From: Official Information
Sent: Friday, 9 March 2018 4:54 p.m.
To: '██████████@fairfaxmedia.co.nz'
Subject: LGOIMA 18/029 response - wellheads material

Christchurch City Council (CCC) commissioned CH2M Beca Ltd (CH2M Beca) to carry out a review of 25 water supply wells at 9 primary water supply pump stations against *Bore Water Security Criterion 2 (bore head must provide satisfactory protection)* of the Drinking Water Standards New Zealand 2005 (revised 2008) (DWSNZ). The scope of works included inspecting the bores and determining their compliance with Criterion 2, recommending upgrades to improve bore head protection and DWSNZ compliance, and summarising the findings with one report per water scheme. This report summarises the findings for the wells supplying Dunbars Pumping Station.

6. Assessment of Bore Water Security Criterion 2 – Bore head must provide satisfactory protection

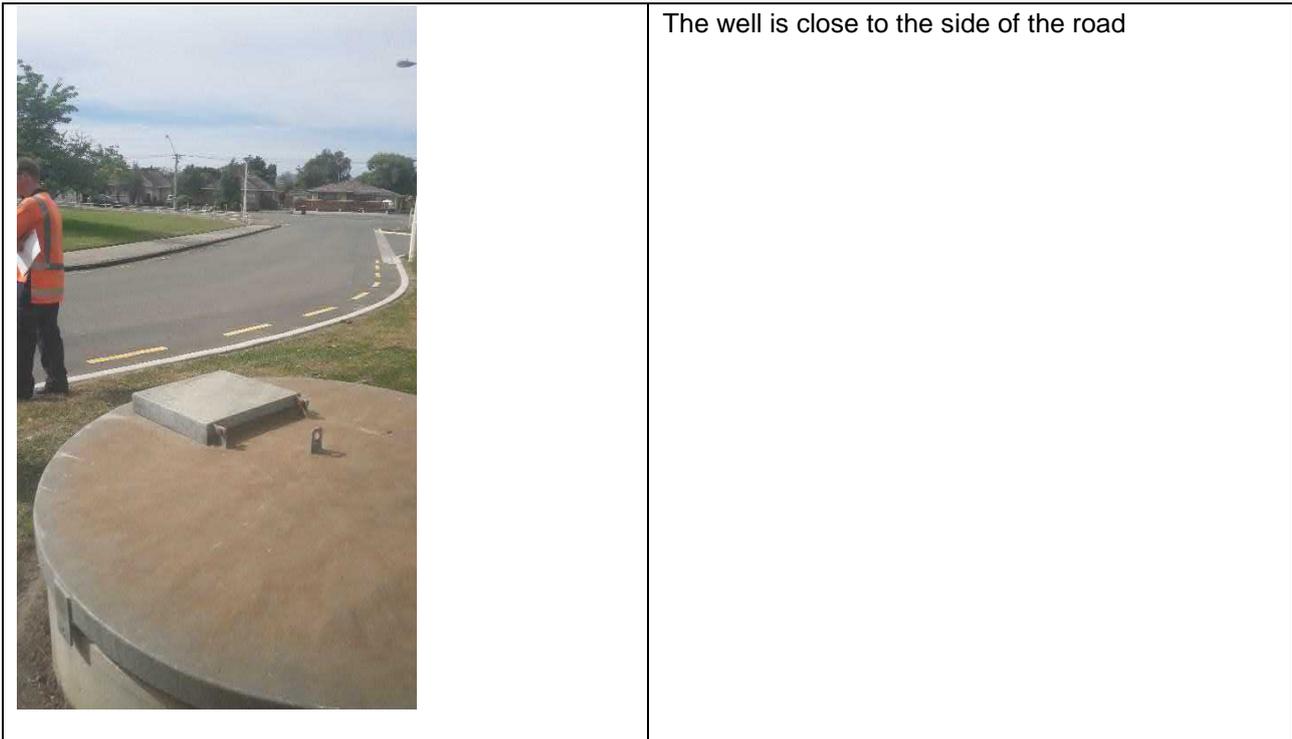
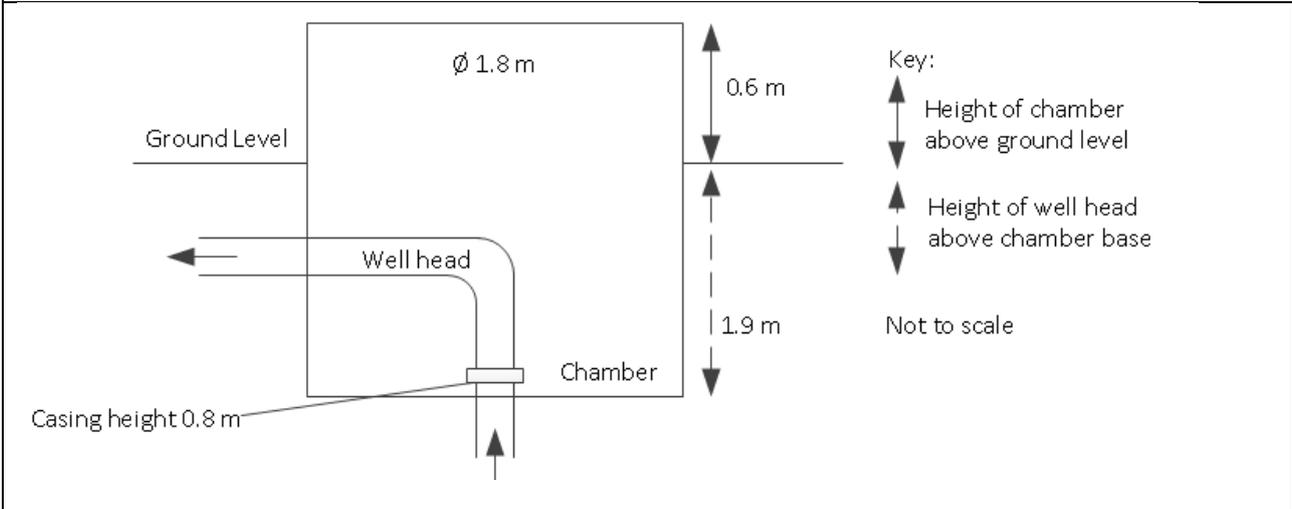
Chamber floor not sealed

Chamber side wall may not be sealed

Old suction tank now disconnected

Old well nearby

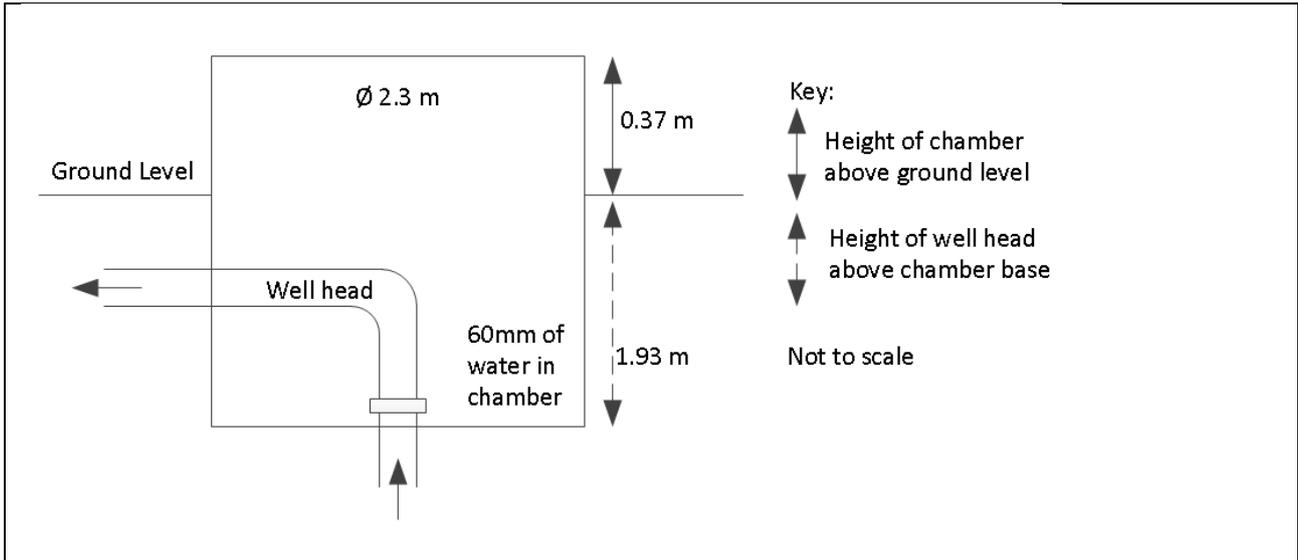
<p>Sample tap discharges into chamber. This may be the source of the water in the bottom</p>
	<p>Surface rust on casing. Sump installed but no sump pump.</p>
	<p>Pipe penetration through chamber appears to be sealed.</p>
<p>5. Diagram with Well Measurements</p>

a) Water Ingress:		
Condition of seals (see NZS:4411 2.5.5.3 & 2.5.5.4)	Cabling	No cables
	Pipework	Sealed with sidewall of chamber
	Well casing	Appears to be sealed from photos. Chamber could not be accessed
Any history of E. coli transgressions? Historical and current levels of total coliforms?		No E. coli transgressions recorded in the data received (dating back to 2012-13 FY). Total coliform levels are unknown
Sanitary well seal watertight or elevated 0.5m above 100 year flood level		Unknown Some of the site is below the 50 year flood level and so there is the potential for flooding. The flood level at this bore is not known
Downward facing air vent 0.5m above 100 year flood level		Not installed
Type and condition of borehead pipework (above ground)		Surface rust
Raw Water sample port?		Yes, in chamber
Concrete apron sloped to drain away from well?		No
100mm step above ground level?		No
Signs of ponding?		Only in the chamber

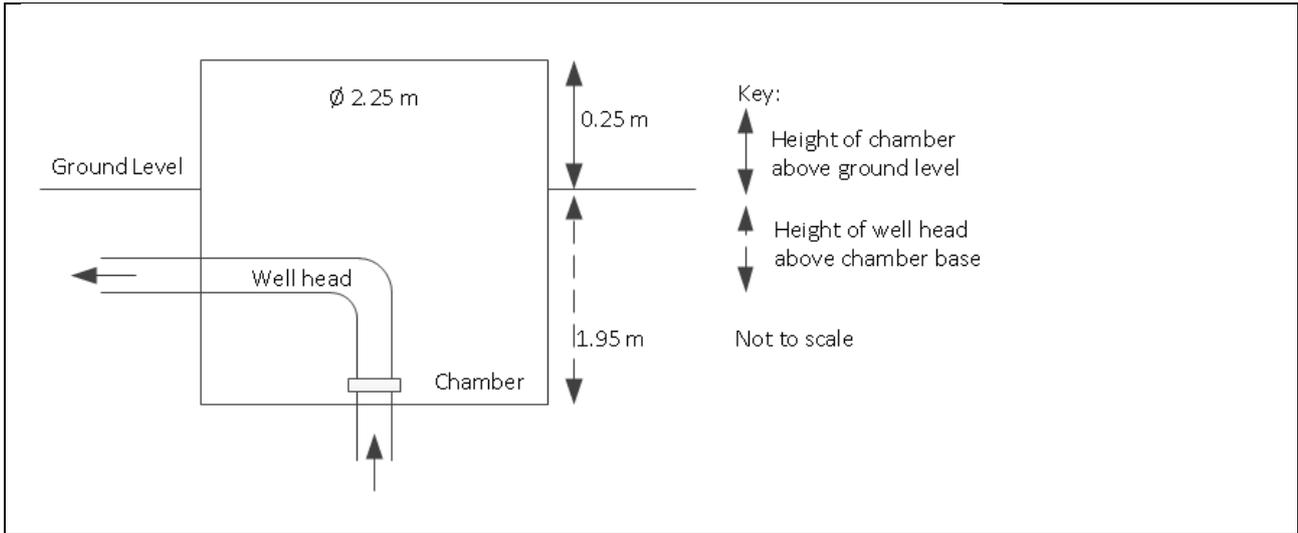
4. Photo Record and Comments	
Photo	Comment
	<p>Pipe work has some surface rust. Chamber is dry.</p>
	<p>Bore casing has some surface rust. Casing appears to be sealed with chamber floor.</p>
	<p>Pipe penetrations through chamber side wall are sealed</p>
5. Diagram with Well Measurements

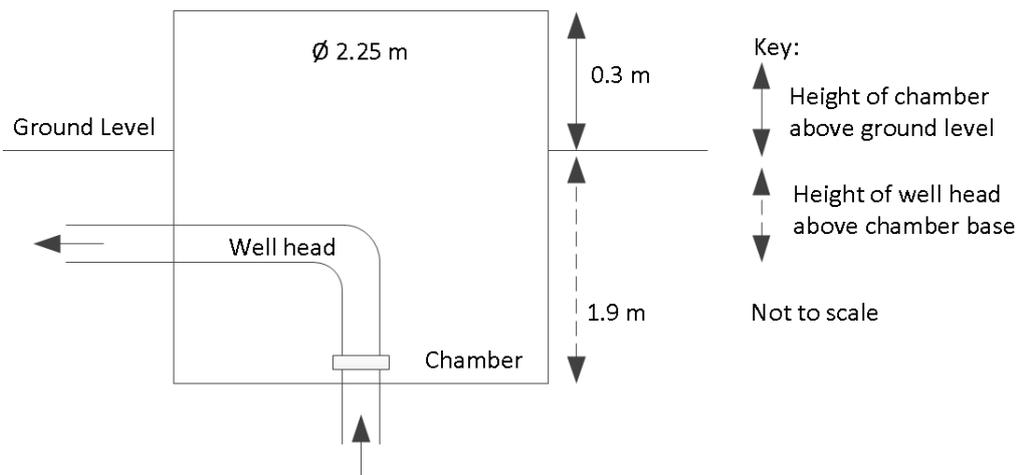
Casing appears to be sealed to chamber floor from photo.

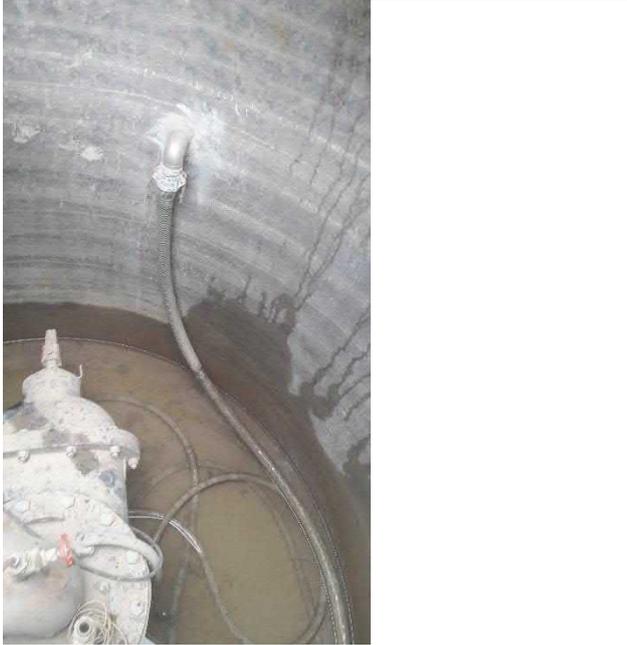
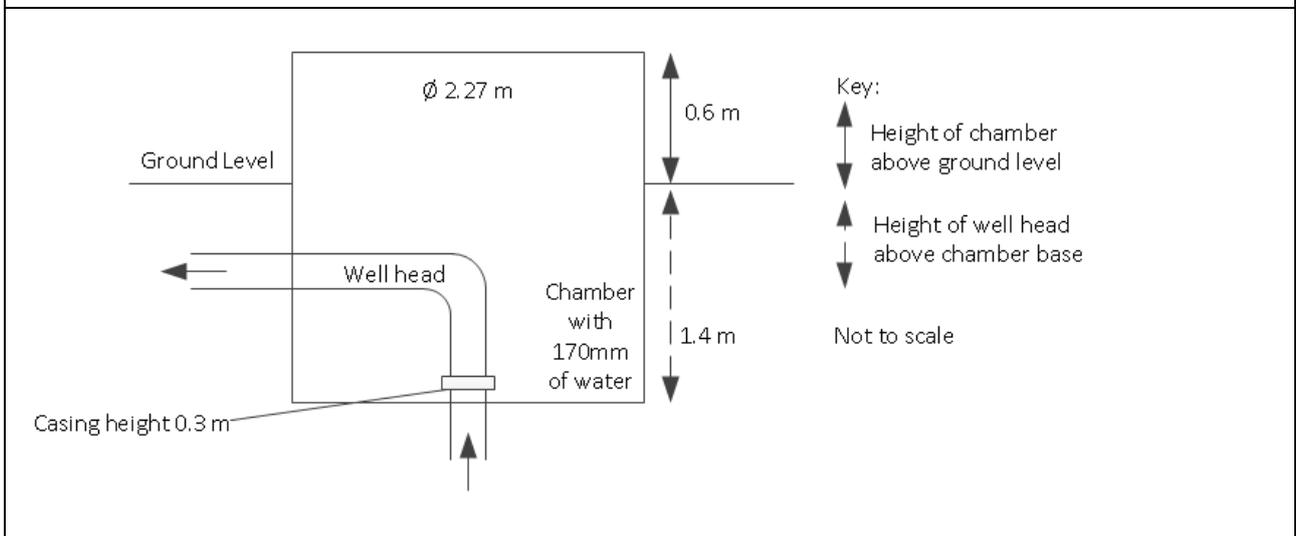
Type of Pump	Submersible
Frequency of Pump Use	Daily in summer, weekly in winter
4. Photo Record and Comments	
Photo	Comment
	Well chamber is located on the side of the road within a park. Park was closed due to construction works at the time of inspection. Site grading does not promote the flow of water away from the chamber.
	Sample tap drains into chamber.
	Water in the bottom of the chamber (~170mm) which may be from the sample tap, the ducts, from a hole behind the electrical cable, lid or chamber floor. It is possible that the nearby construction work has had an effect on this.

<p>Pipe penetration through chamber wall is sealed.</p> <p>Leaking down from the top of the chamber</p>
	<p>Chamber wall penetration sealed</p>
	<p>Potential leak from behind the electrical cabinet.</p> <p>Note that the sump pump is not sitting in the sump.</p>

<p>Casing may not be sealed to chamber floor. It appears that sediment is coming up from the ground below the chamber.</p>
---	--

<p>Cable glands may not be sealed</p>
--	---------------------------------------

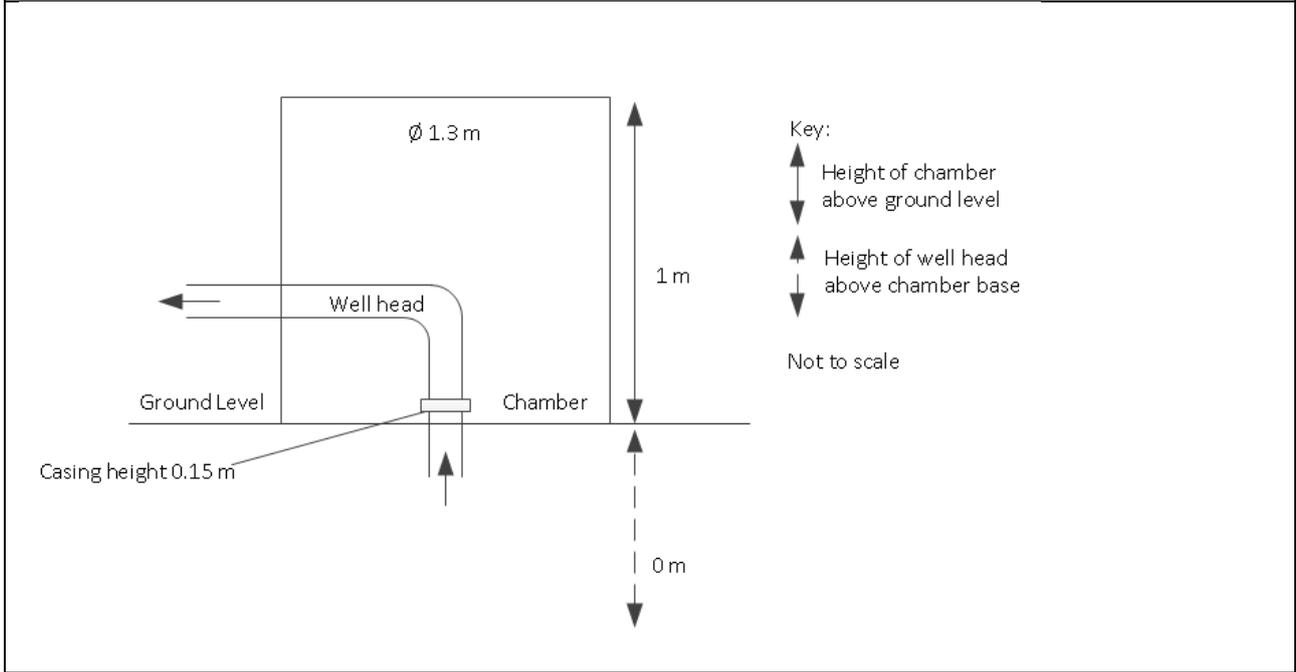
<p>Well casing has some surface rust. Appears to be sealed with chamber floor</p>
	<p>No vermin control on drain hole</p>

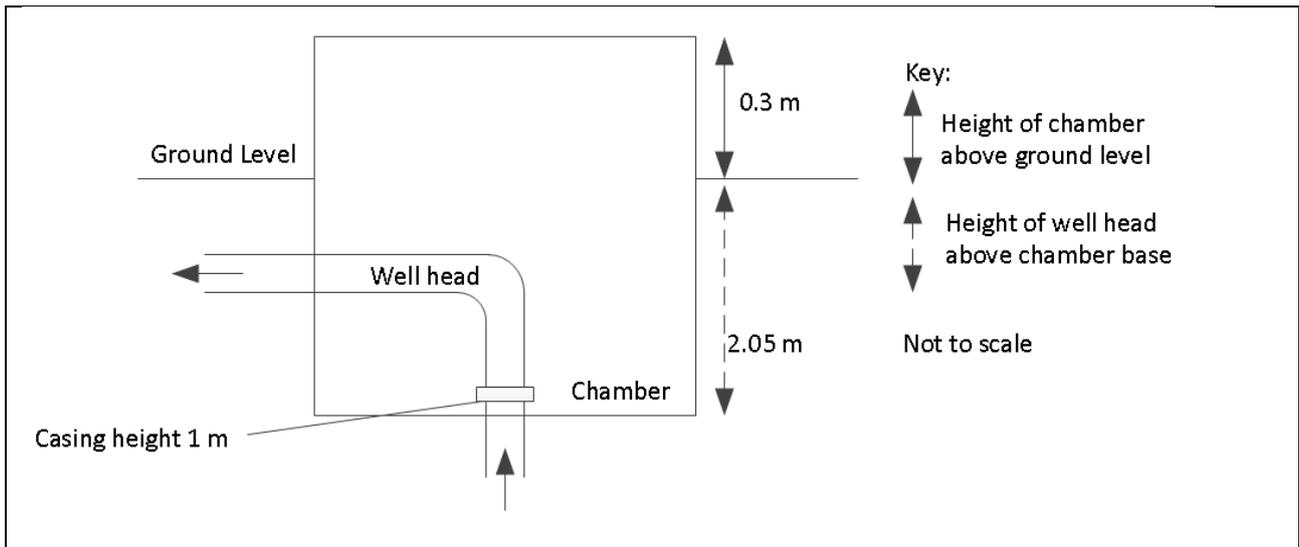
<p>Pipe penetration through chamber wall is sealed</p>
	<p>Casing approximately 1m above the chamber floor. Casing appears to be sealed to chamber from photos taken. Chamber could not be entered</p>
	<p>Cable entry to chamber not sealed</p>
<p>5. Diagram with Well Measurements</p>

a) Water Ingress:		
Condition of seals (see NZS:4411 2.5.5.3 & 2.5.5.4)	Cabling	Sealed at casing entry but not at chamber wall
	Pipework	Sealed with chamber wall
	Well casing	Sealed with chamber floor
Any history of E. coli transgressions? Historical and current levels of total coliforms?	Only distribution system E. coli transgressions have been recorded in the data received (dating back to 2012-13 FY). No transgressions have been recorded at the well in this data Total coliform levels are unknown	
Sanitary well seal watertight or elevated 0.5m above 100 year flood level	No – cabling entry at chamber wall not sealed Some of the site is below the 50 year flood level and so there is the potential for flooding	
Downward facing air vent 0.5m above 100 year flood level	Not installed	
Type and condition of borehead pipework (above ground)	Good condition	
Raw Water sample port?	Yes, in cabinet next to chamber

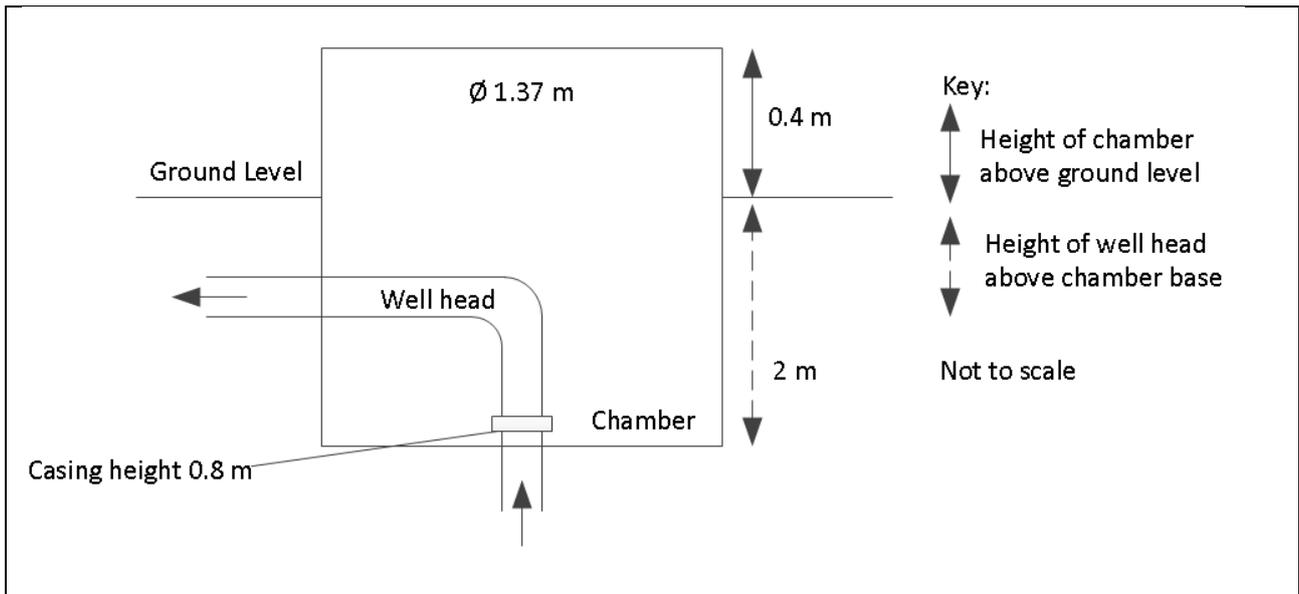
<p>Frequency of Pump Use</p>	<p>Generally runs every day or two to maintain level in suction tank</p>
<p>4. Photo Record and Comments</p>	
<p>Photo</p>	<p>Comment</p>
	<p>Well location</p>
	<p>Casing condition – some surface rust</p>
	<p>Casing and chamber connection appears to be sealed from photos although the chamber could not be entered.</p>
	<p>Well chamber</p>
<p>5. Diagram with Well Measurements</p>

a) Water Ingress:		
Condition of seals (see NZS:4411 2.5.5.3 & 2.5.5.4)	Cabling	Cable entries appear to be sealed (although chamber could not be entered)
	Pipework	Sealed with sidewall of chamber
	Well casing	Casing to chamber appear to be sealed (although chamber could not be entered)
Any history of E. coli transgressions? Historical and current levels of total coliforms?		Only distribution system E. coli transgressions have been recorded in the data received (dating back to 2012-13 FY). No transgressions have been recorded at the well in this data Total coliform levels are unknown
Sanitary well seal watertight or elevated 0.5m above 100 year flood level		Yes Some of the site is below the 50 year flood level and so there is the potential for flooding
Downward facing air vent 0.5m above 100 year flood level		Not installed
Type and condition of borehead pipework (above ground)		Good condition
Raw Water sample port?		Yes, in chamber

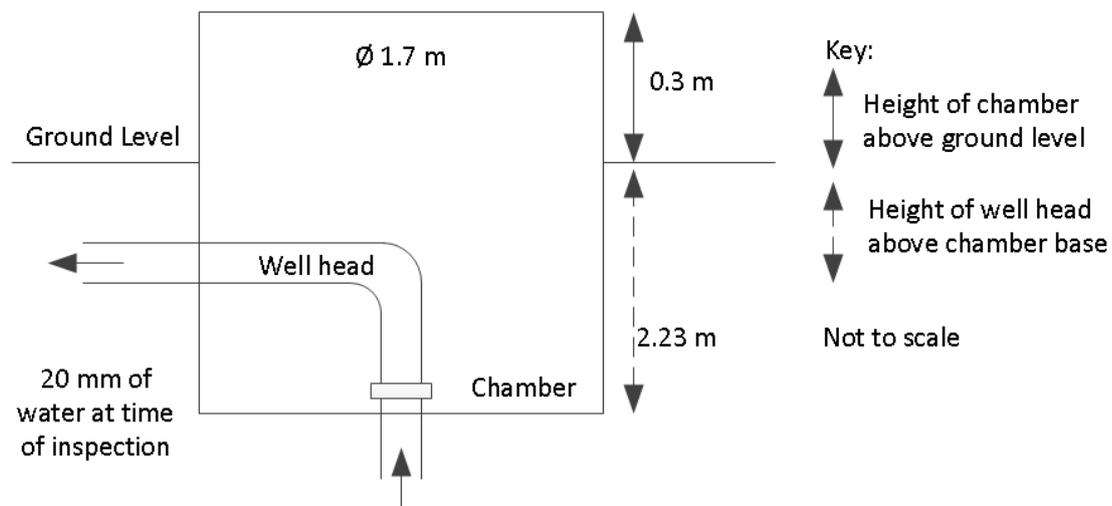
Sample tap entry to chamber not sealed

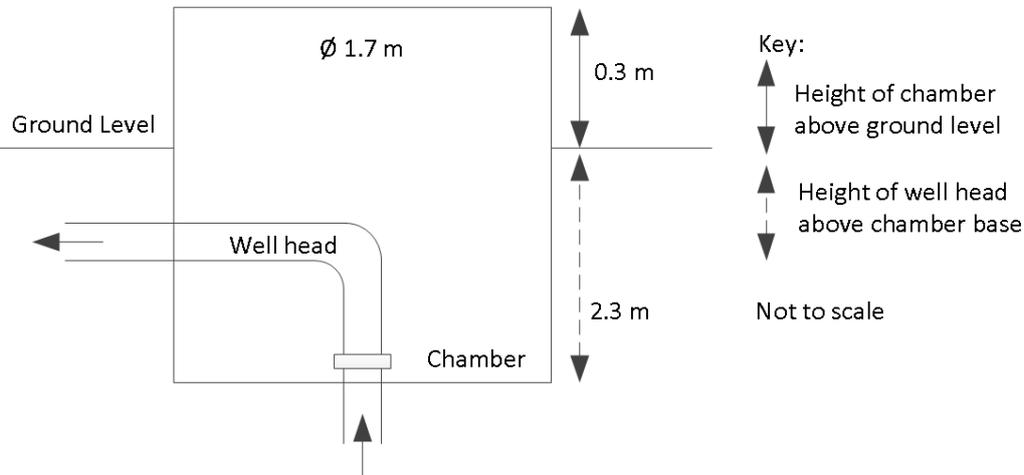
<p>Frequency of Pump Use</p>	<p>Generally runs every day or two to maintain level in suction tank</p>
<p>4. Photo Record and Comments</p>	
<p>Photo</p>	<p>Comment</p>
	<p>Well location</p>
	<p>Bore head – pipe glands not sealed</p>
	<p>Casing in reasonable condition with some rust</p>
	<p>Pipe to wall entry not sealed</p>

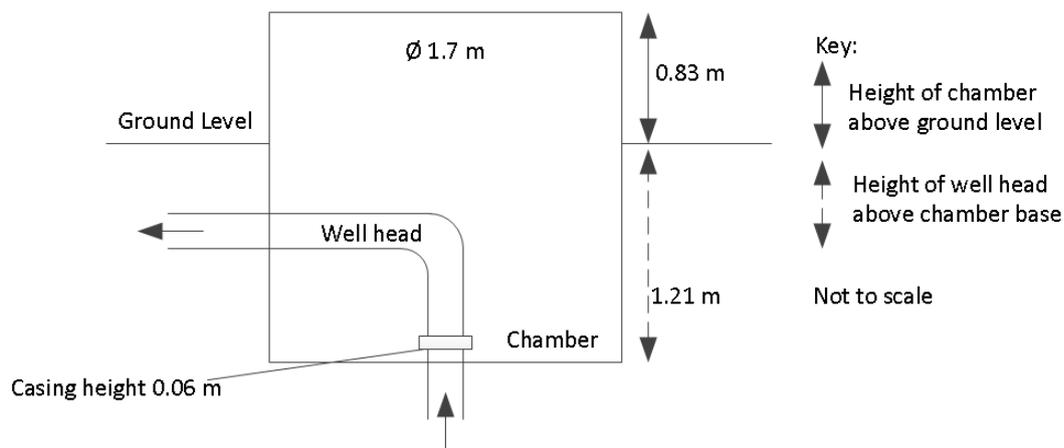
<p>Frequency of Pump Use</p>	<p>Generally runs every day or two to maintain level in suction tank</p>
<p>4. Photo Record and Comments</p>	
<p>Photo</p>	<p>Comment</p>
	<p>Well chamber floor. Casing to floor connection could not be viewed as the chamber could not be accessed.</p>
	<p>Pipework is rusty Chamber floor appears to be damp but on closer inspection it was found that sparkling spider webs cause the damp look.</p>
	<p>Pipework to chamber sidewall connection appears to be sealed.</p>
	<p>Cable penetrations through the chamber sidewall are not sealed</p>

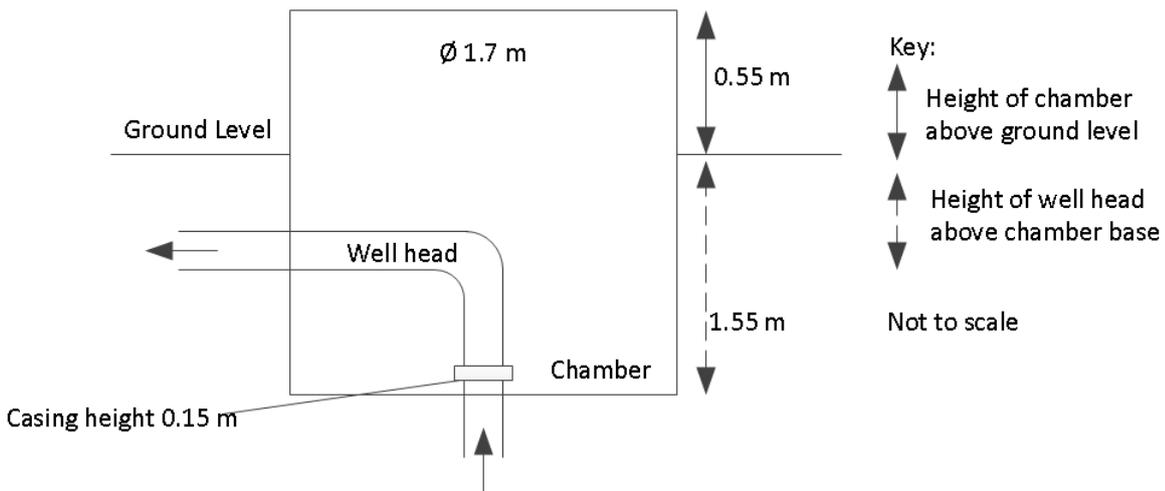
Cable chamber penetrations not sealed
